## Product part number: SLG46400

### Active SLG46400 Errata List

#### ISSUE 4: Internal RC OSC frequency difference

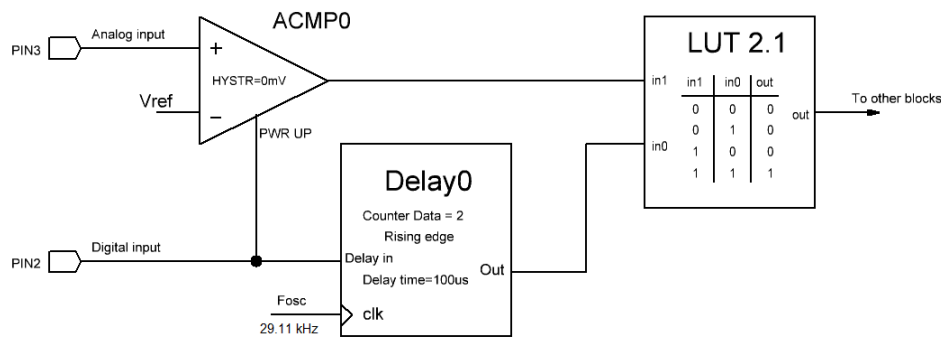
The SLG46400 Rev. B chips have difference in internal RC OSC frequency options. For example, reg<586:583> = 0000b option will set the RC OSC to 28.93kHz at VDD=3.3V in SLG46400 Rev. B chips and 27.74kHz in SLG46400 Rev. A chips, reg<586:583> = 0011b option will set the RC OSC to 122.3kHz at VDD=3.3V in SLG46400 Rev. B chips and 308.27kHz in SLG46400 Rev. A chips.

- Recalculate Counter Data for Counter/Delay blocks.
- Choose another frequency option from the list.

## **ISSUE 11: ADC data can't reach 255**

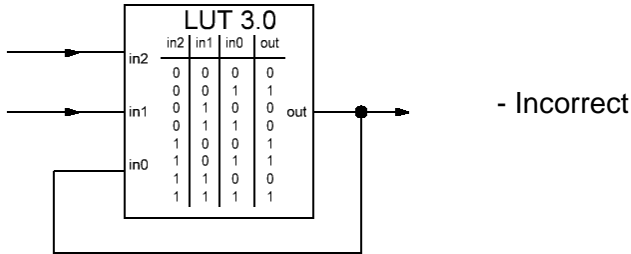
For VDD<2V and PGA Bypass to ADC mode the ADC data can't reach 255 value

- Use external divider to shift the input voltage range, so the maximal voltage is less than 800mV.

## **ISSUE 12: LUT starts with output high when the feedback from its output to IN0 is used.**

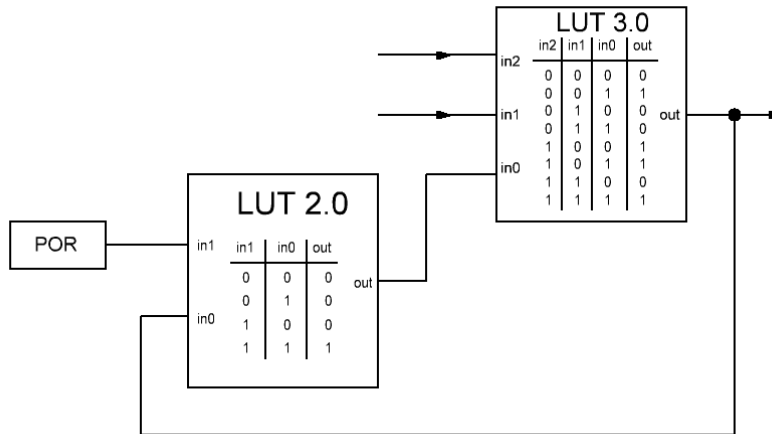
LUTs configured to have a feedback from its OUT to IN0 and truth table contains the situation, for 2-bit LUT IN1=0, IN0=1, OUT=1, for 3-bit LUT IN2=0, IN1=0, IN0=1, OUT=1, for 4-bit LUT IN3=0, IN2=0, IN1=0, IN0=1, OUT=1 can start with OUT HIGH (see example below).

- Use another input for LUT, or add AND cell with POR as one of its inputs (see below).

### ISSUE 13: Chip's operation is incorrect after startup

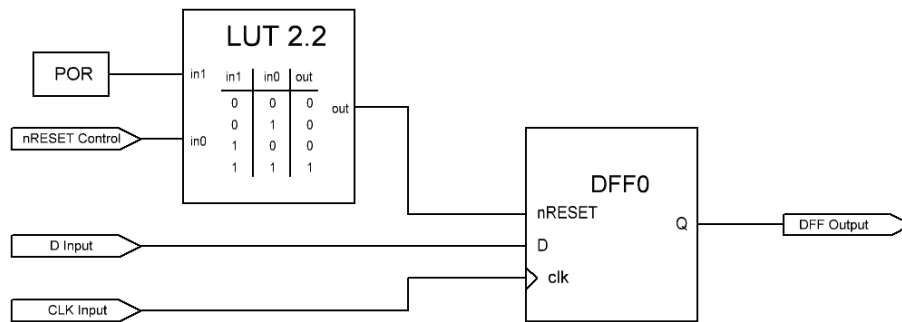
Chip can halt or configure improperly if the VDD low voltage is higher than 40mV.

- Make sure the VDD rail should be discharged slower than 0.5V/ms before ramping back up.

## ISSUE 16: Incorrect Delay time

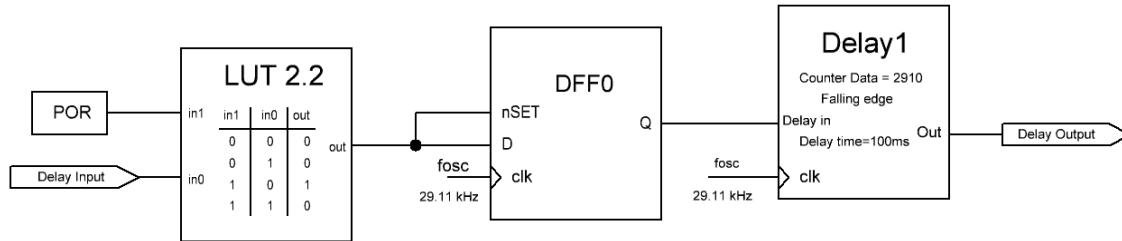
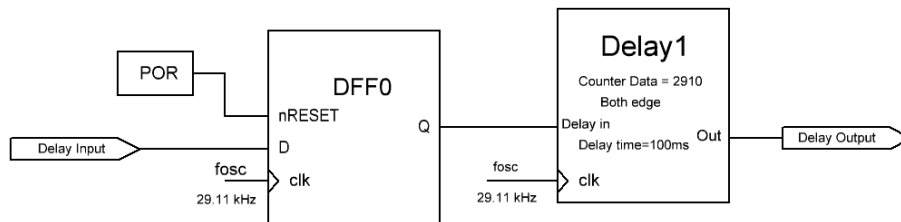
If the input edge of the Delay (or reset of Counter) is very close (<1ns) to the rising edge of the sourced clocking signal (RC OSC is Forced Power On or operating because another blocks request) the Counter/Delay cell might have incorrect Counter Data loaded.

- Use synchronization block on the Counter/Delay input, similar to that shown below.  
In case of Rising Edge Delay:

In case of Falling Edge Delay:

In case of Both Edges Delay:

### ISSUE 17: LATCH0 and LATCH1 nSET or nRESET operation is incorrect

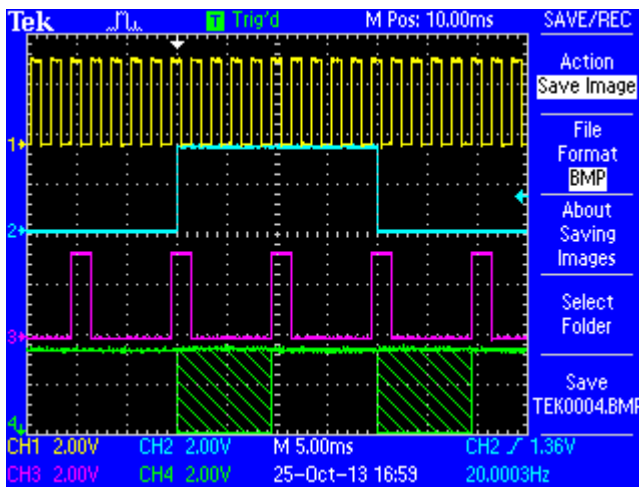
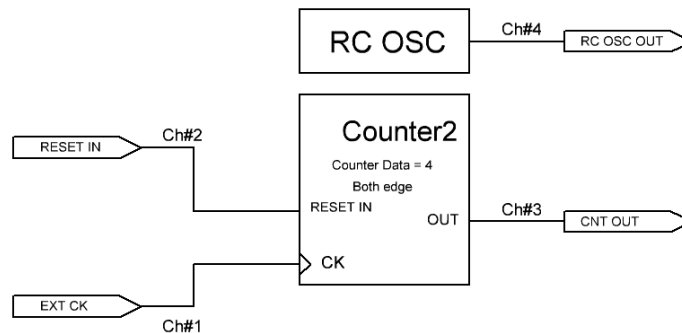
The nSET or nRESET functions of LATCH units operate incorrect. LATCH unit operates only when nSET/nRESET node is sourced with HIGH level signal.

- Currently there is no workaround. Please see the truth tables of LATCH blocks below:

## ISSUE 18: Counter with external clock starts internal RC OSC operation when reset

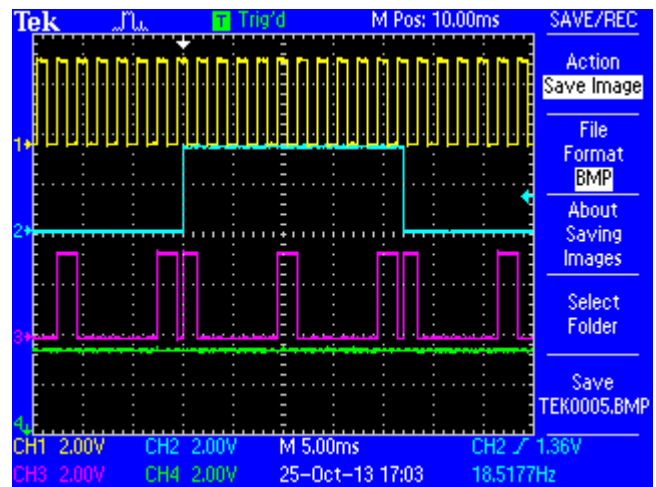
CNT2 and CNT3 (FSM0 and FSM1) have a possibility to be sourced from external RC OSC signal and have RESET signal at the same time. While block is in a reset state (when finished counting cycle and output is logic HIGH) and the defined RESET edge appears the internal RC OSC will start its operation until counter enters the next reset state.

Reset Edges came up with Reset state

- Currently there is no universal workaround. If the RSC should be powered down all the time its Shared Power Down can be set to be controlled from matrix and SHARED PD input connected to HIGH level source.
